**VILLAGE OF WAUNAKEE / TOWN OF WESTPORT  
JOINT PLAN COMMISSION  
Town of Westport Community Room  
5387 Mary Lake Road  
April 9, 2019 6:00 PM**

**To:** Village of Waunakee Plan Commission  
**From:** Jason Valerius, AICP  
**Subject:** Kilkenny West GDP  
**Date:** April 1, 2019

Re: Kilkenney West General Development Plan (GDP) and Certified Survey Map (CSM)  
Village of Waunakee (Village)

## SITE PLAN

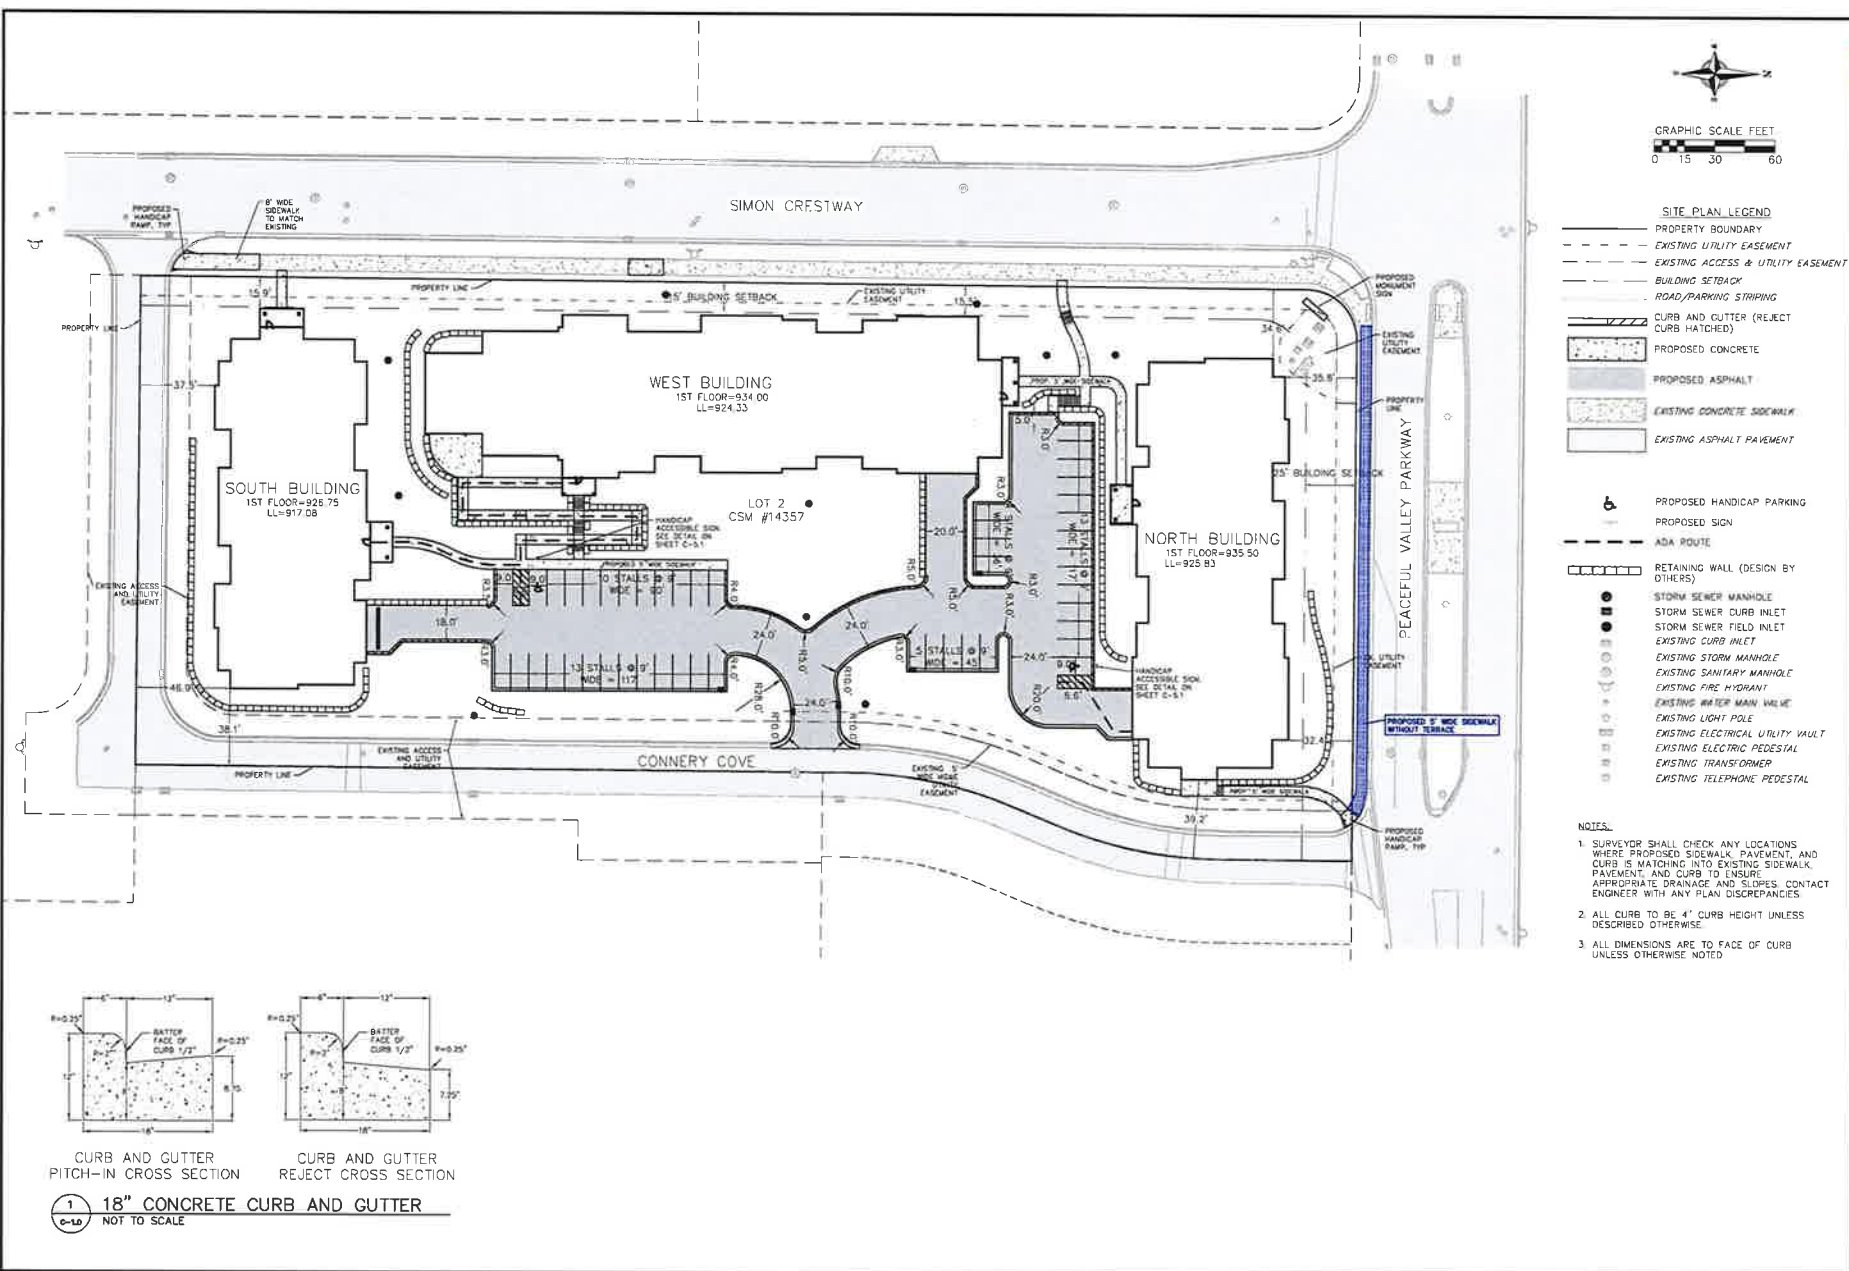
- 3) Add sidewalks around the east and south sides of the site, and show ADA-compliant connections from every building to the west sidewalk (enabling access to commercial uses west of this site). Add pedestrian connections from the buildings and/or through the parking lots to the east sidewalk. A sidewalk is also encouraged along Peaceful Valley Parkway, recognizing that it likely requires additional right-of-way to achieve.
